Tesla Comments – NOGRR 282

ERCOT LLWG – 1/22/26

# Tesla recommendations on NOGRR 282 phrasing

## Tesla Recommendation

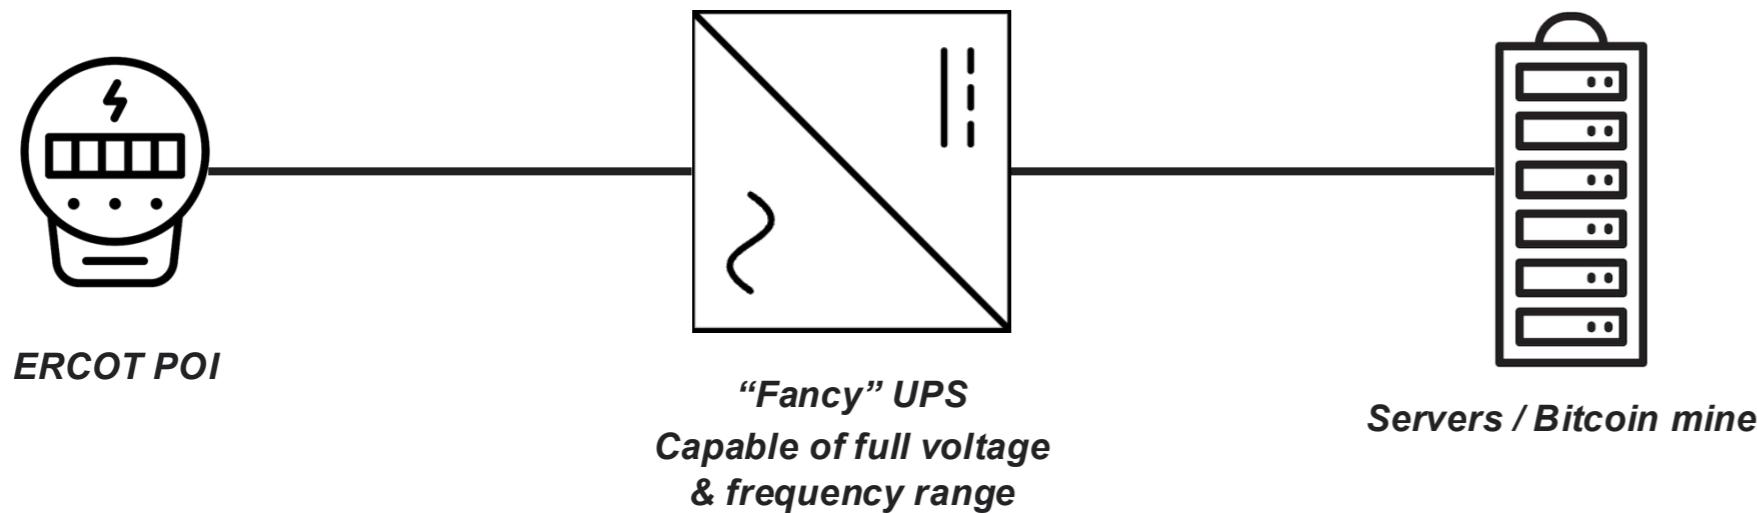
1. “Continue consuming”
  - While not explicit, reads as no “gap” or load draw switching
  - Thus, would require continuous draw from UPS

1. Add <250 millisecond load transfer language
  - Enables ancillary equipment to start drawing current
2. Limit variance frequency
  - “Once per device” to allow for VFDs vs UPS A vs UPS B on a site to have different tripping profiles

*For voltage deviations outside the 0.9-1.1pu range and frequency deviations outside of the 58.8 - 61.2 Hz range, **an internal load-transfer or control stabilization interval of up to 250 millisecond is permitted.***

*For LELs composed of multiple internal devices, one transition will be permitted per disturbance event for each individual device.*

# Load return or mimicking with BESS – Tesla Megapack simulations

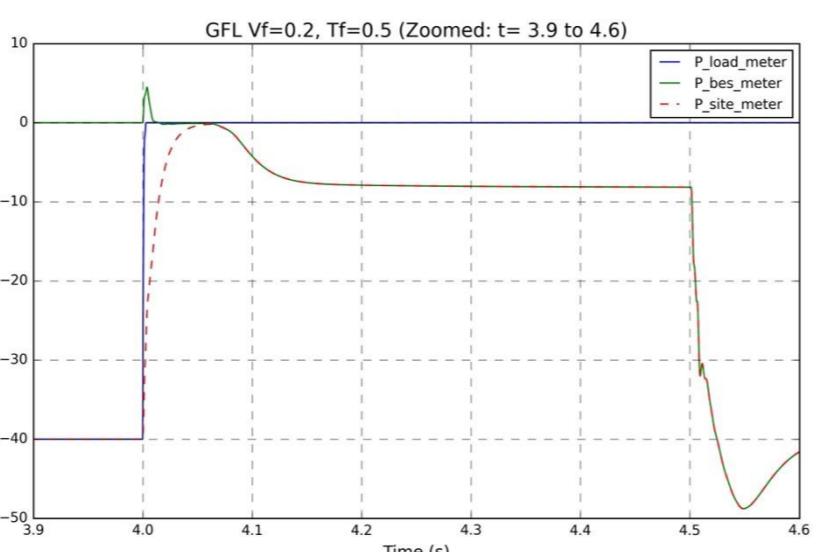
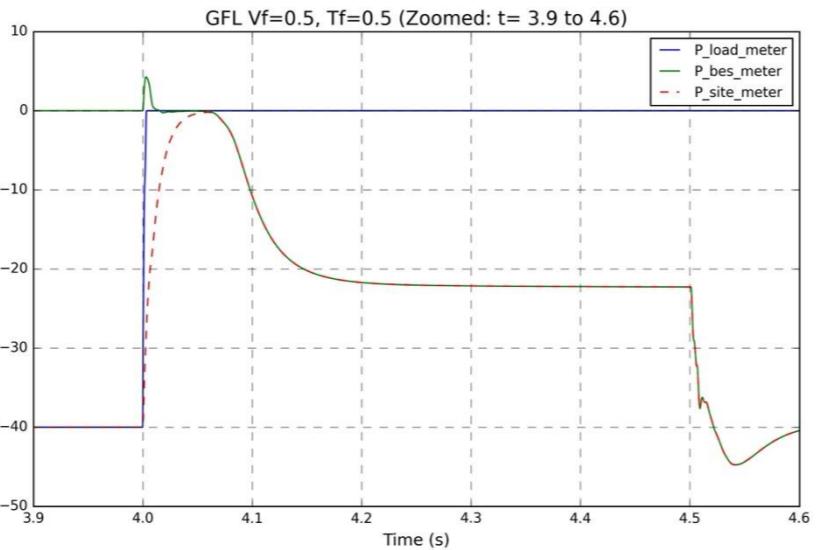
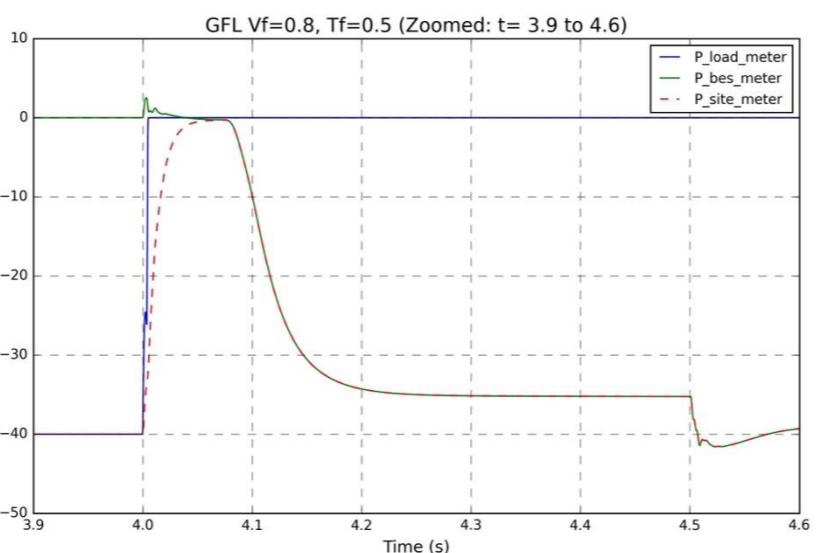
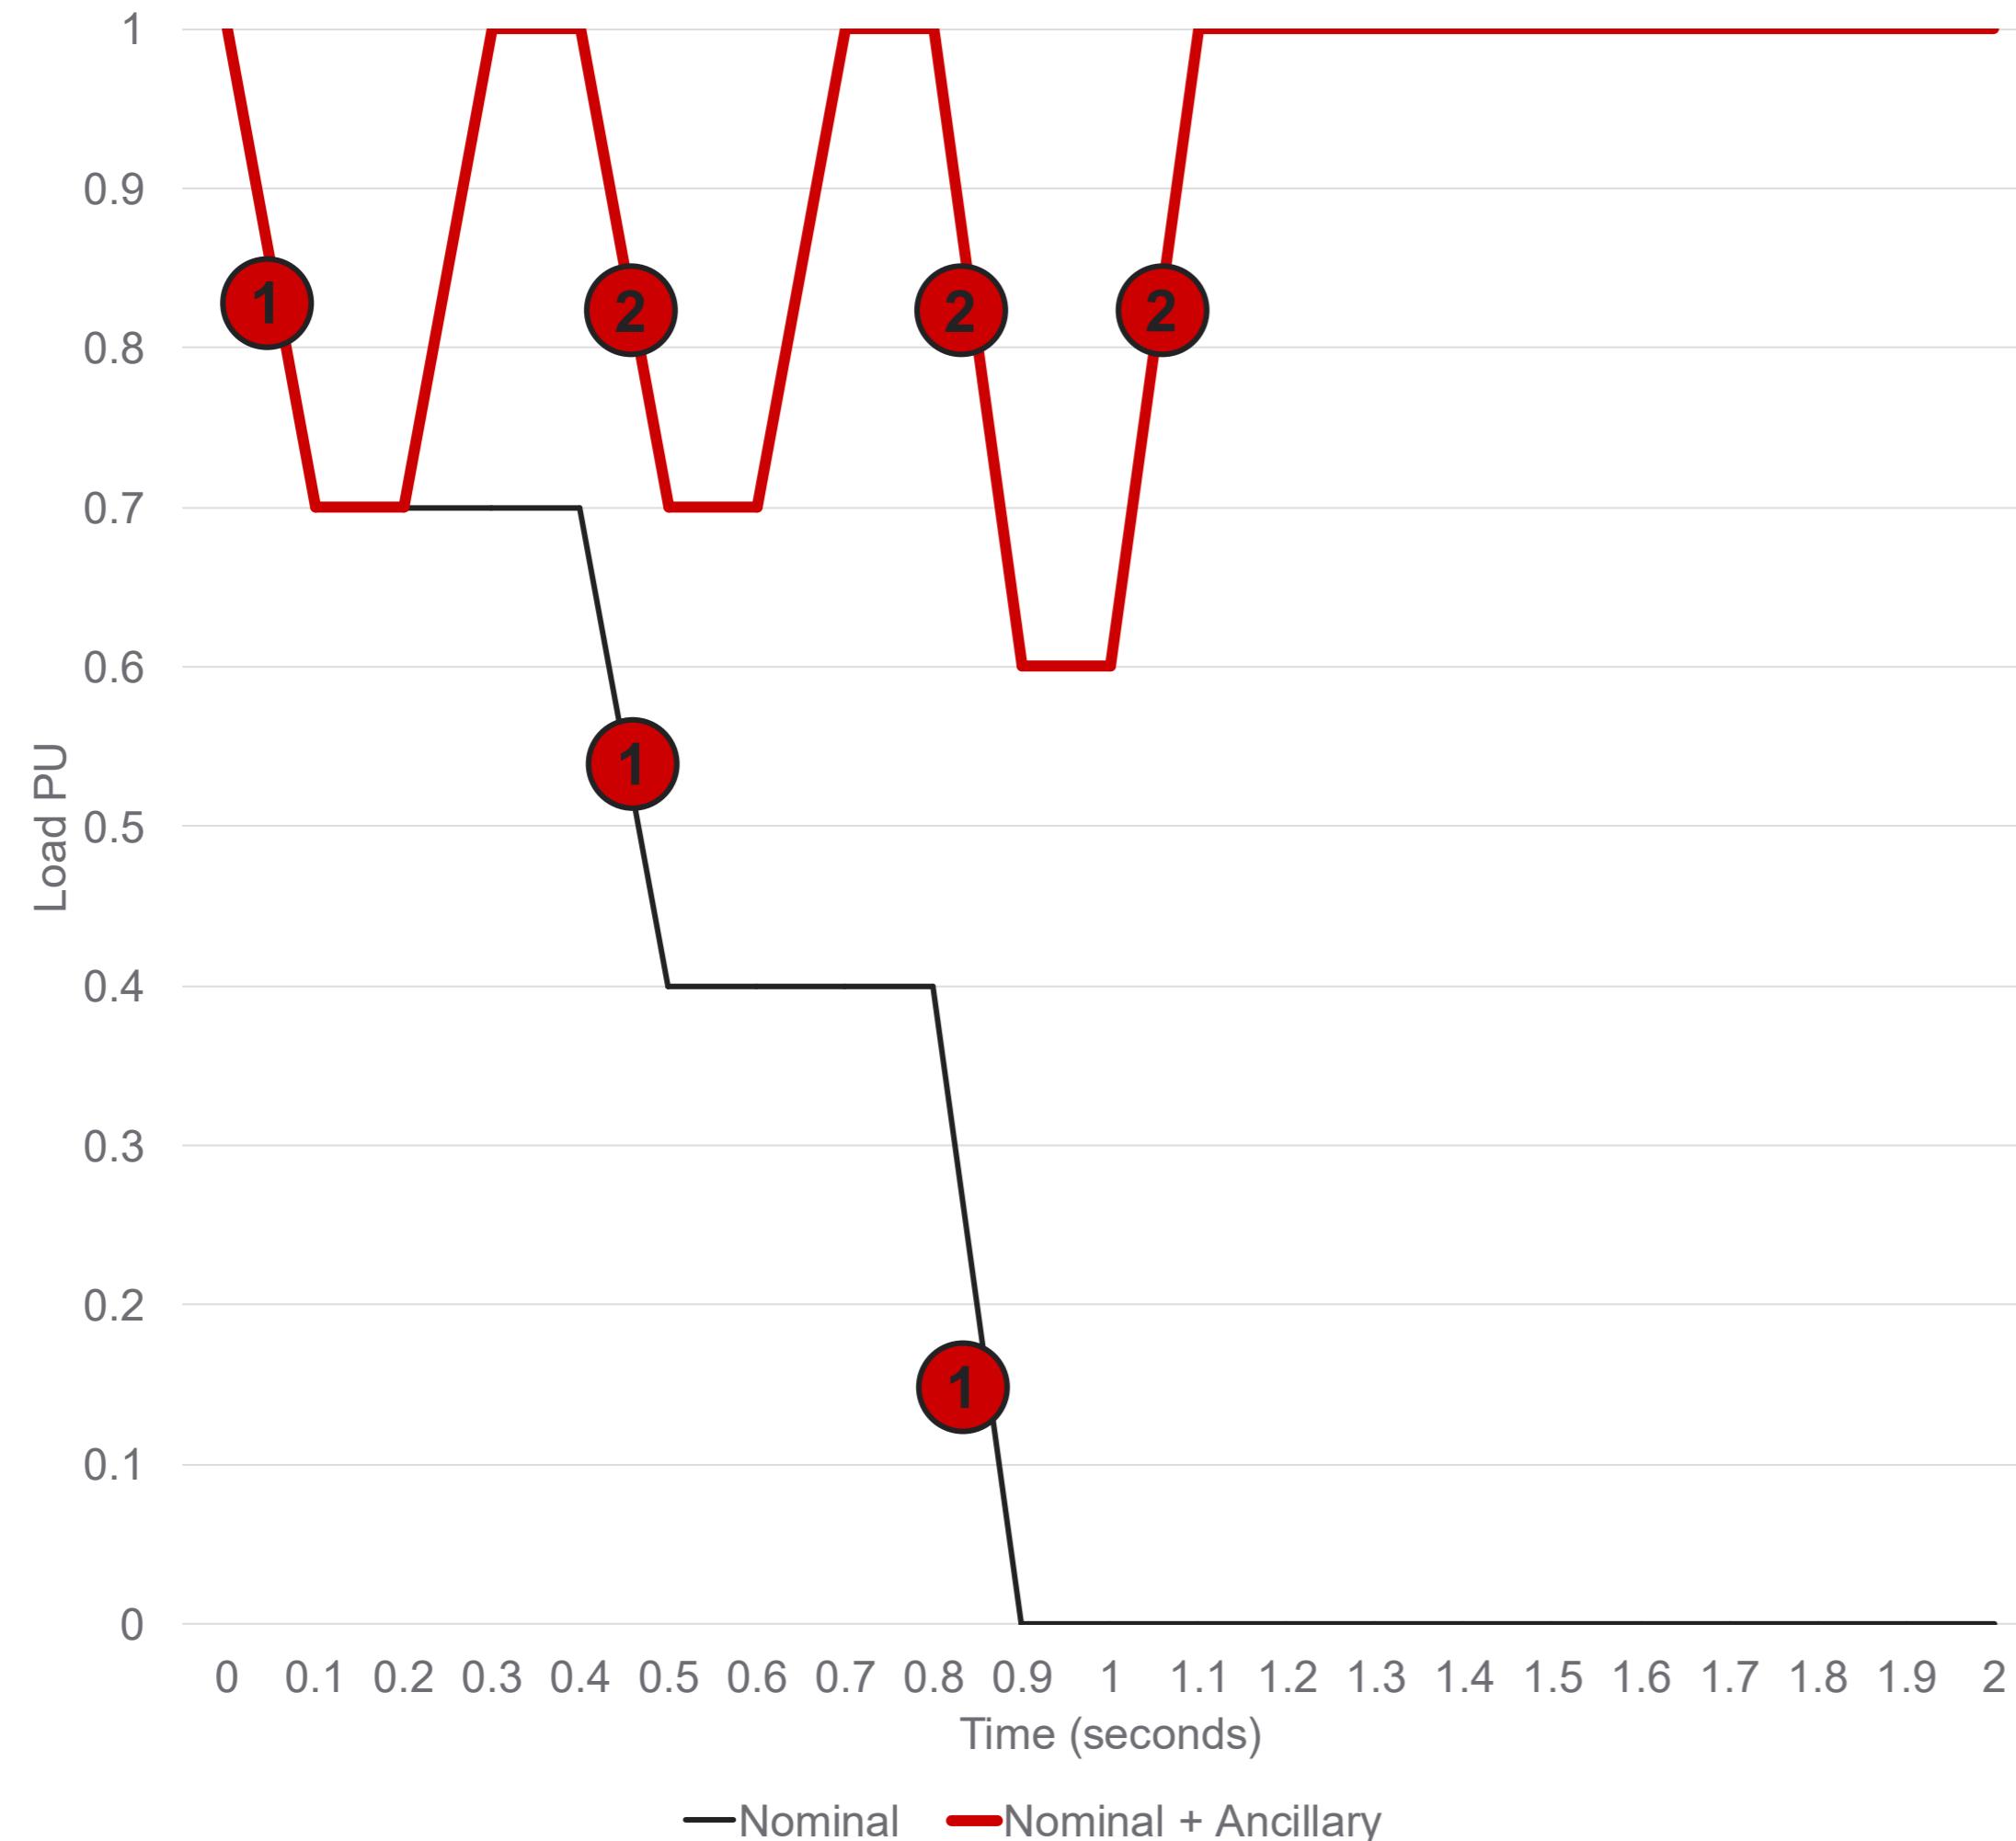
- Varied voltage dips: 0.8, 0.5, 0.2 PU
- 0.5 second fault assumed
- Grid Forming & Grid Following inverter control modes

**Takeaway: BESS mimics load in < 250ms**  
Faster than 500 ms “need”

- Grid following (recommendation)
  - ~150ms current returns to pre-fault
    - Includes during continued fault
    - Likely see derated power for deep sags
  - ~100 ms post fault, power returns to pre-fault
- Grid forming:
  - During fault: focuses on voltage support – injects Q
  - Do not see current draw return as quickly
  - ~100 ms post fault power returns to nominal

# Example of “once per device” language intent

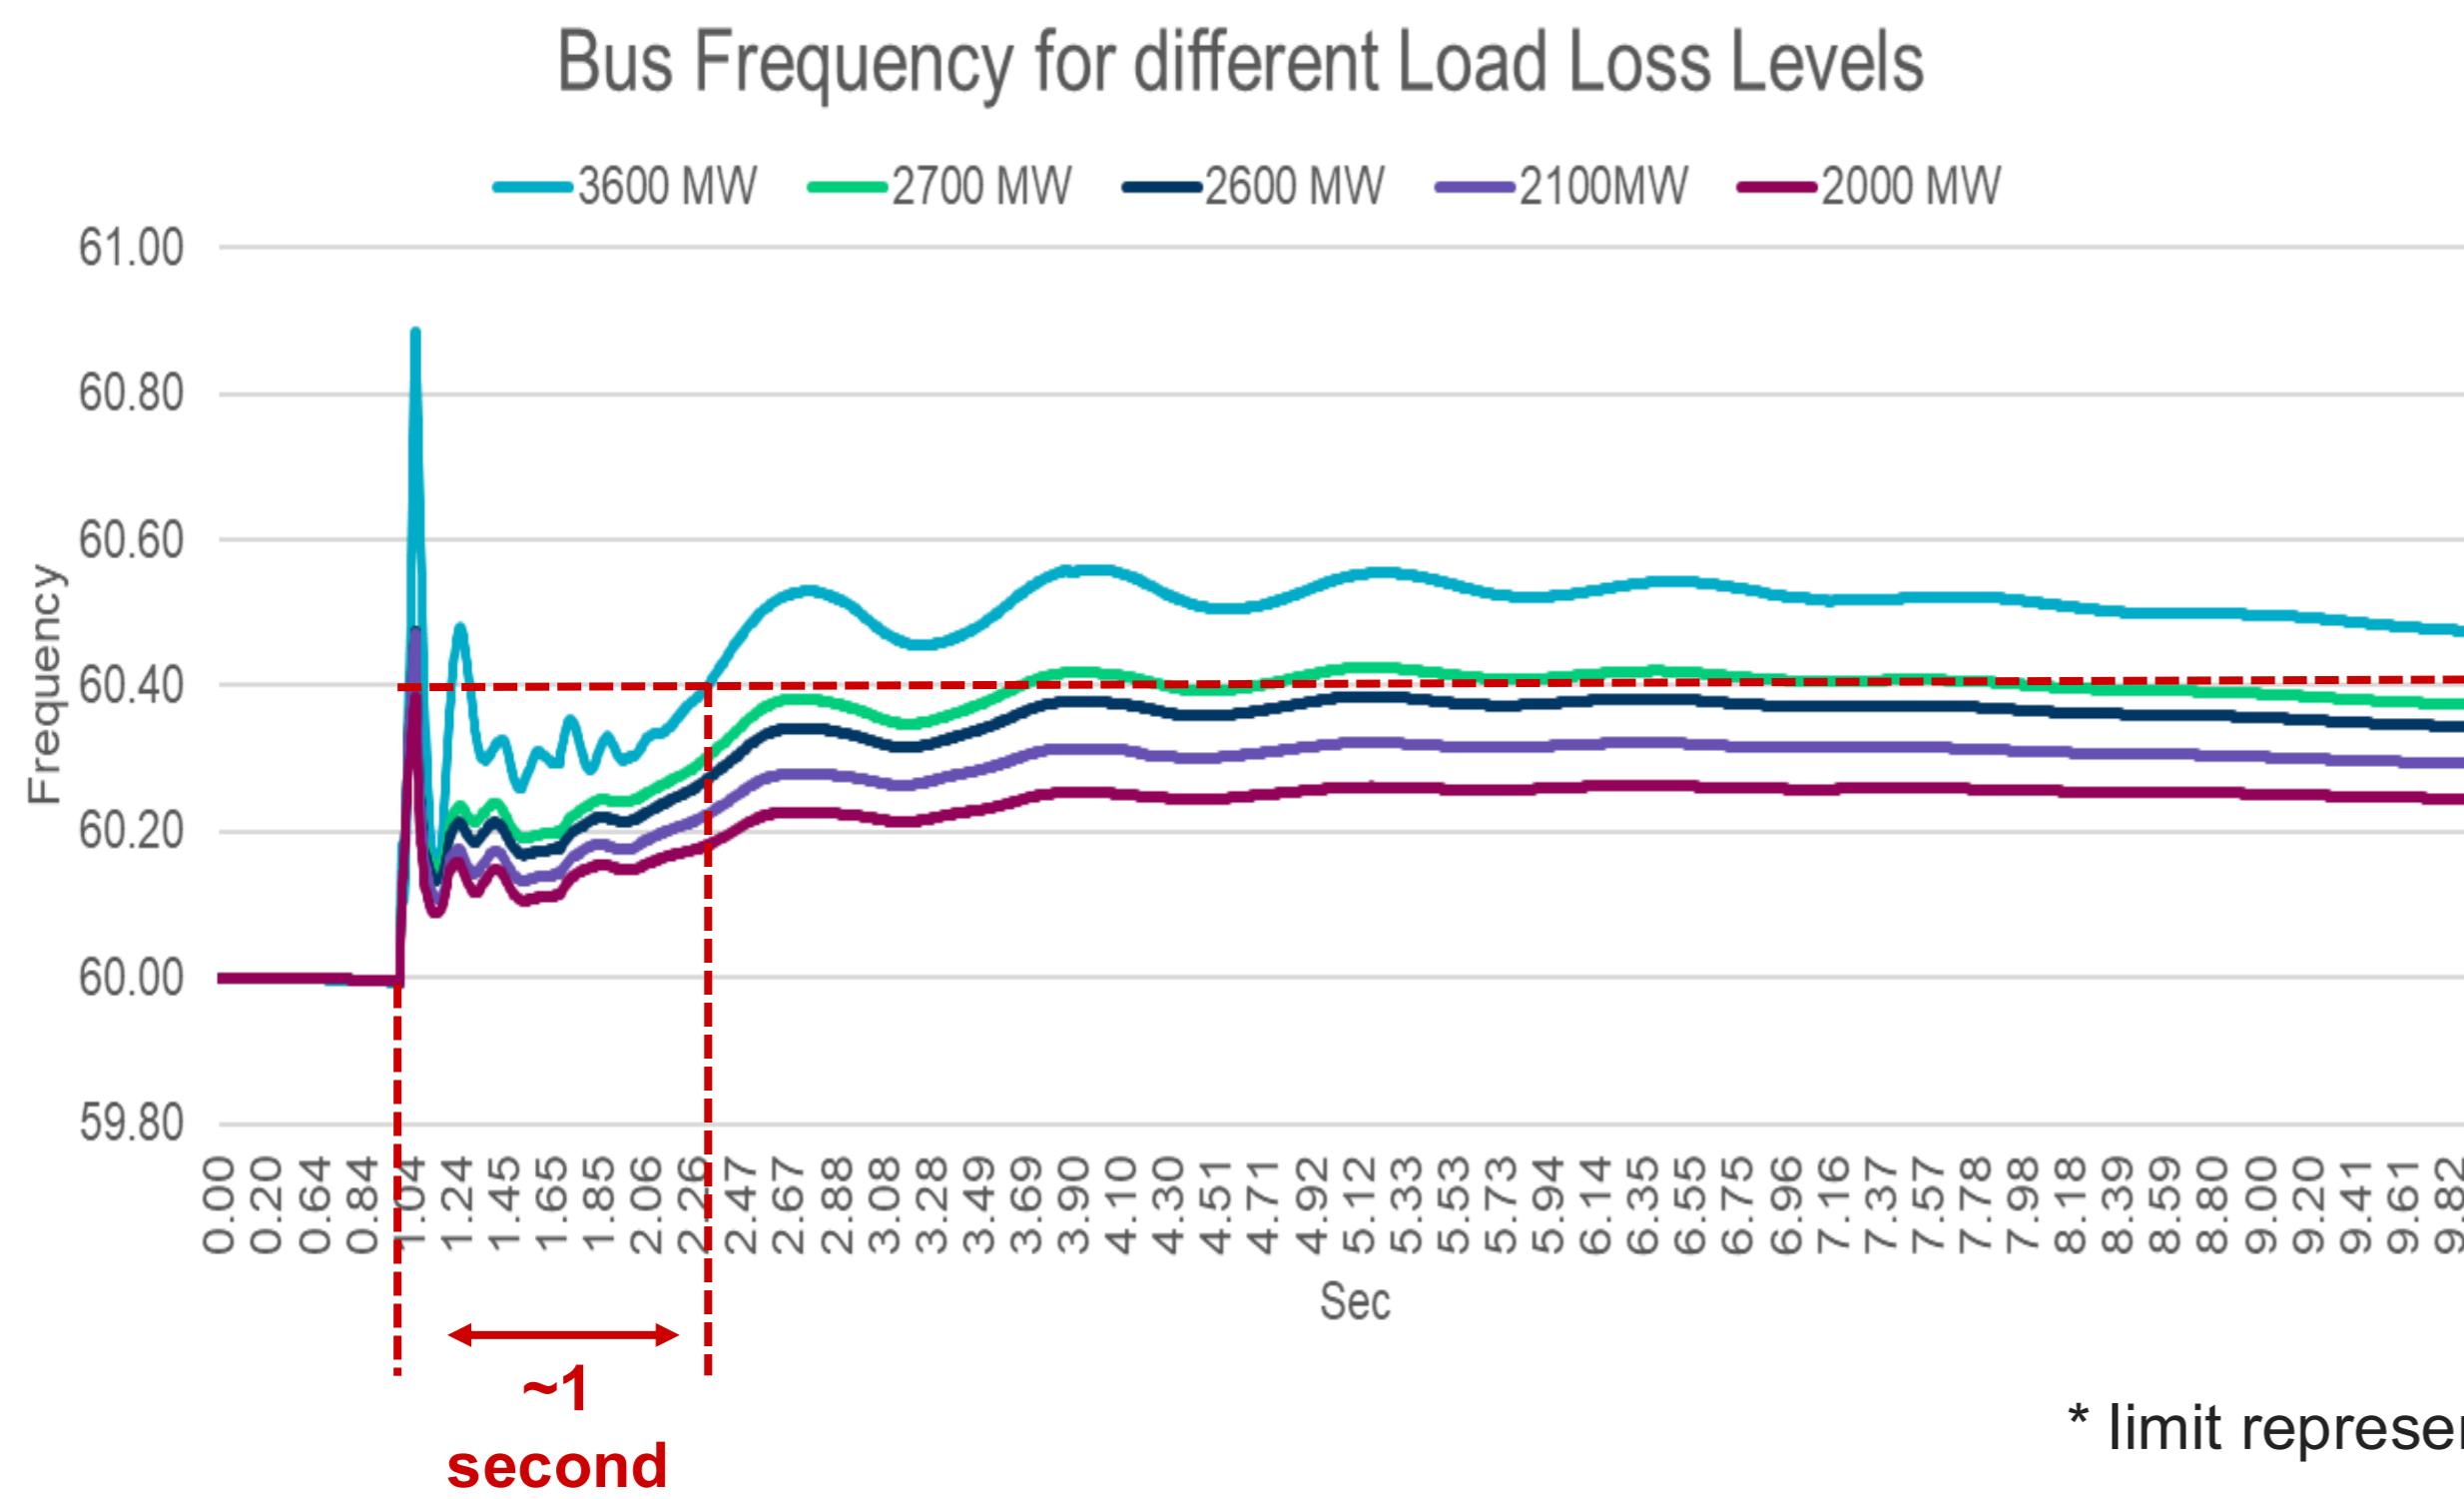
- VFDs vs UPS may have different characteristics
- Different UPS systems may have different capabilities, with a mix installed on site

① Example shows 3 discreet load drops

## Example shows 200 ms ancillary load transition

② Quickly picks up load as it drops

- Intended to add clarity that having differing trip settings on devices is OK
- This would benefit ERCOT stability, as loads get picked up as they drop
  - i.e. in example shows minimum 0.6 pu, which is quickly transferred to ancillary equipment

*For LELs composed of multiple internal devices, one transition will be permitted per disturbance event for each device.*
